Response to Information Request

Development Application for Material Change of Use – Multiple Dwelling (4 Units)

65 Stagpole Street, West End and formally identified as Lot 3 on SP338397

Information Request

DRAWING
DIMENSION PLAN: GROUND FLOOR - PART PLAN 1
PHASE
ISSUE FOR INSTRUCTION (IFC)
SCALE
1:100 @ A3

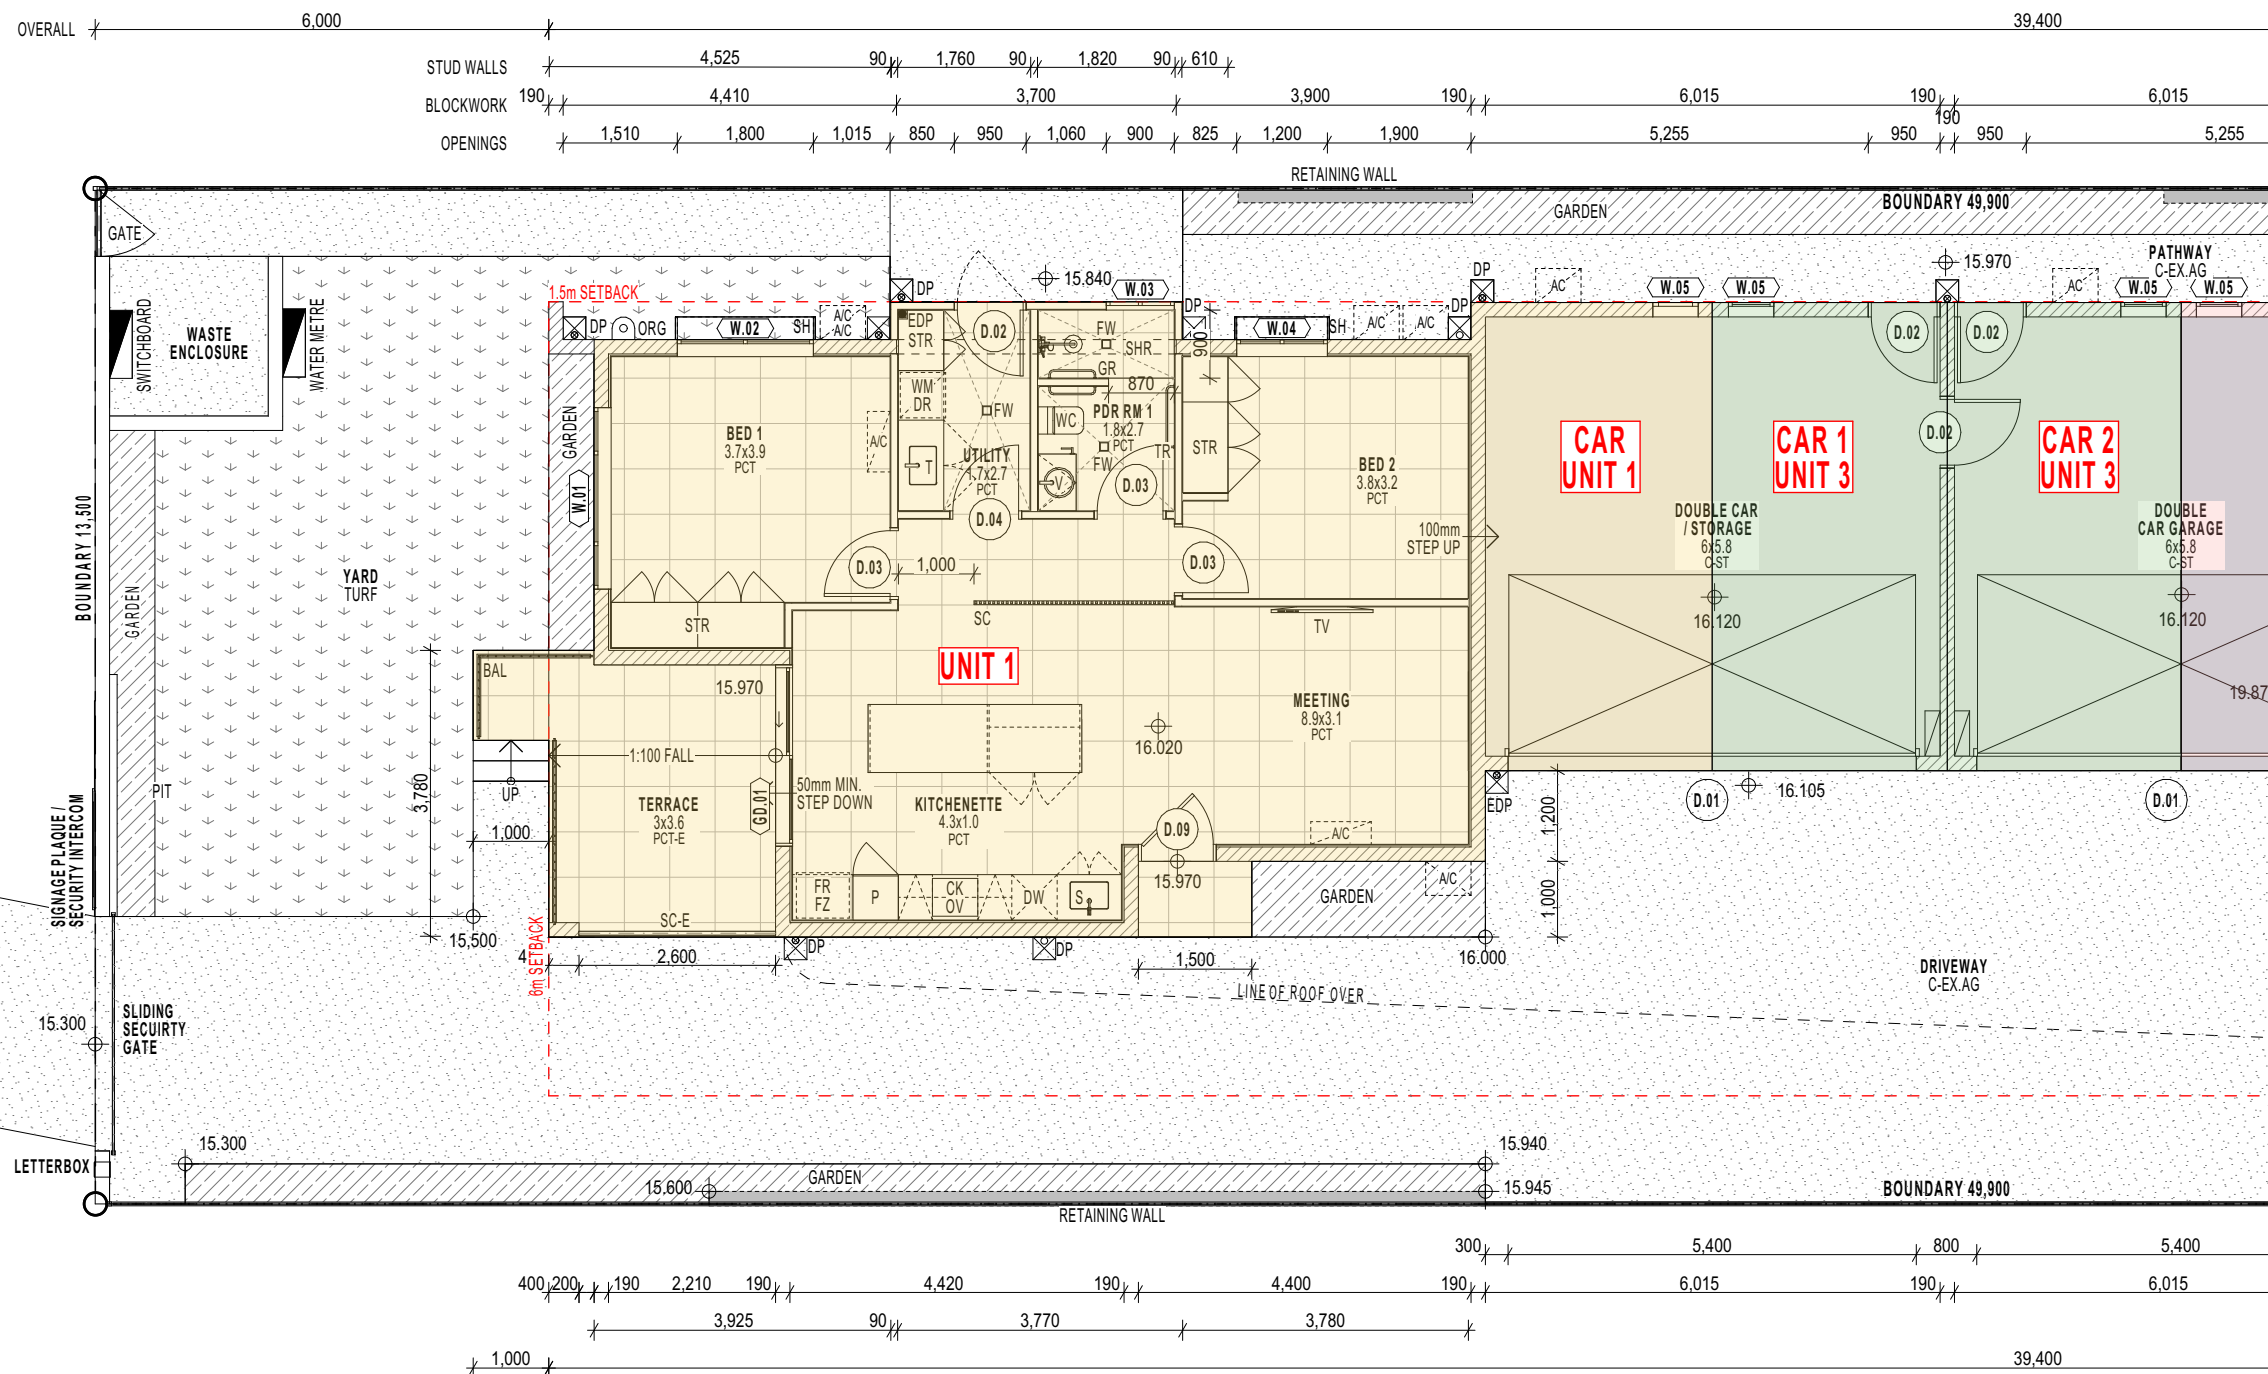
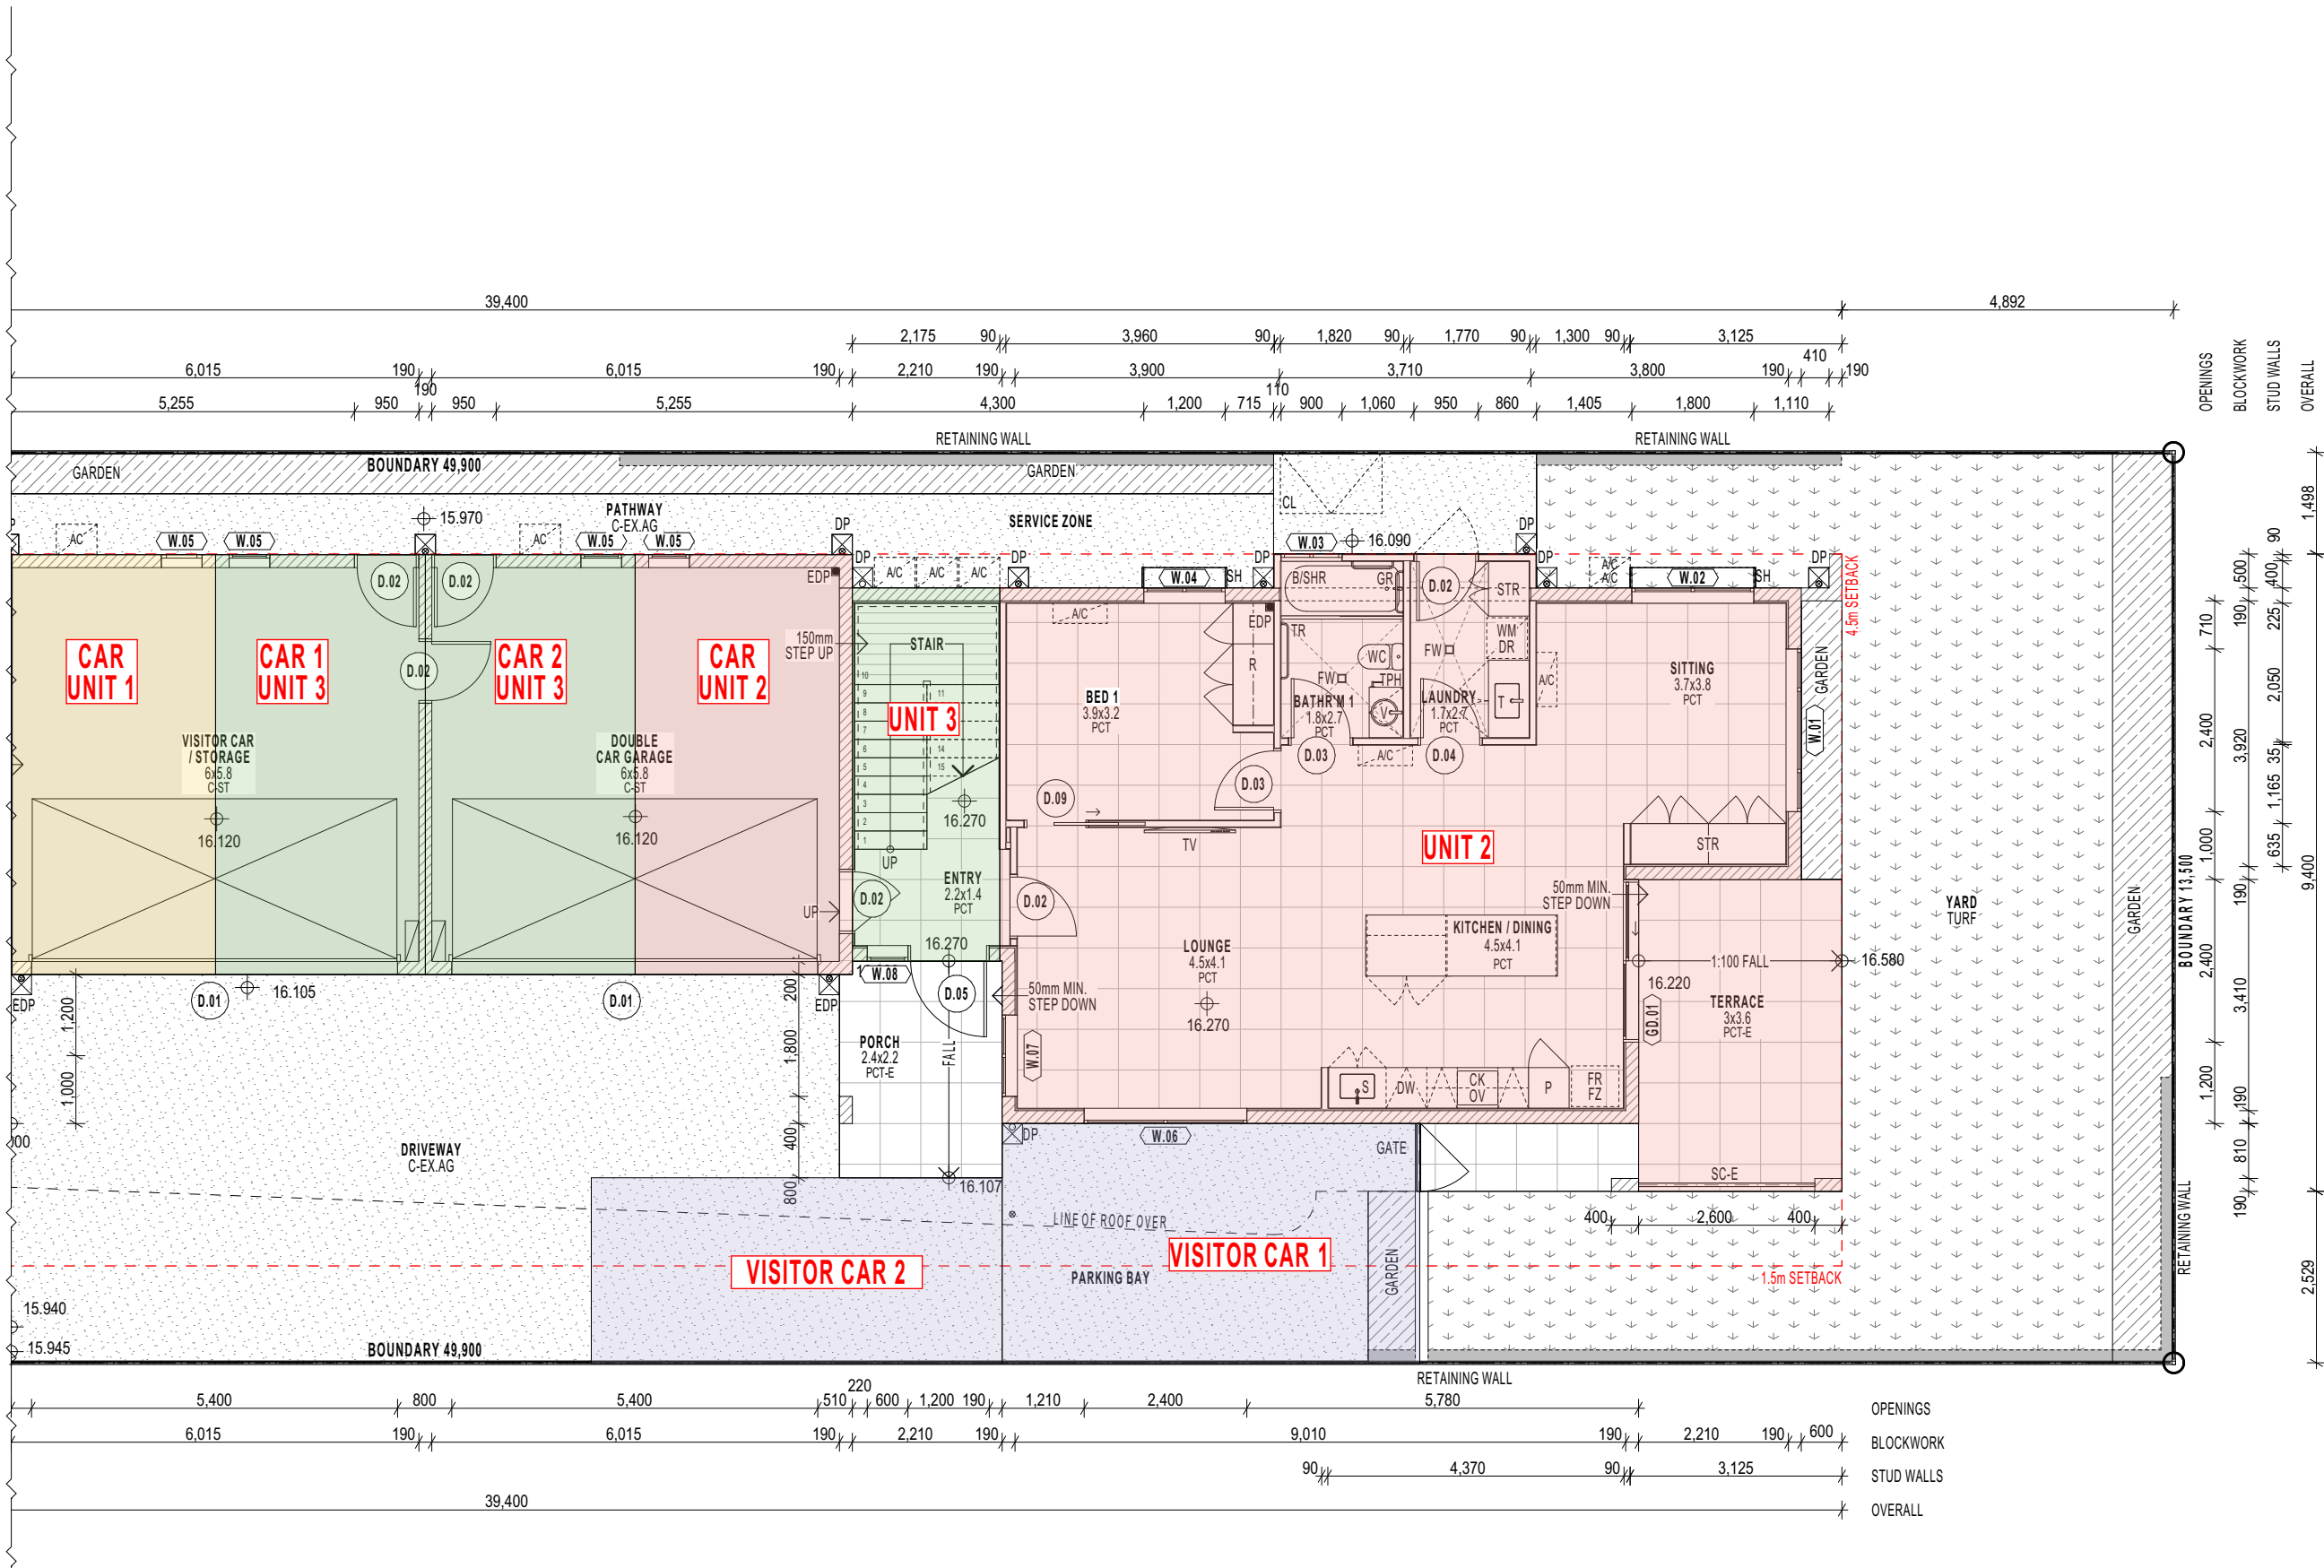
- Removal of 'Office Tayo' and 'Office Rashi' as indicated within Future Unit 1.
- Inclusion of kitchenette and laundry within Future Unit 2 to ensure the unit is self-contained.
- Enclosure/clarification on the shared wall between Future Unit 2 and Future Unit 4.
- Removal of 'Future' labelling throughout proposal plans and/or confirm timing for stages (if relevant).

In response to this item, it's confirmed that each of the requested items have been adopted and included with the amended architectural plans - refer **Attachment 2**.
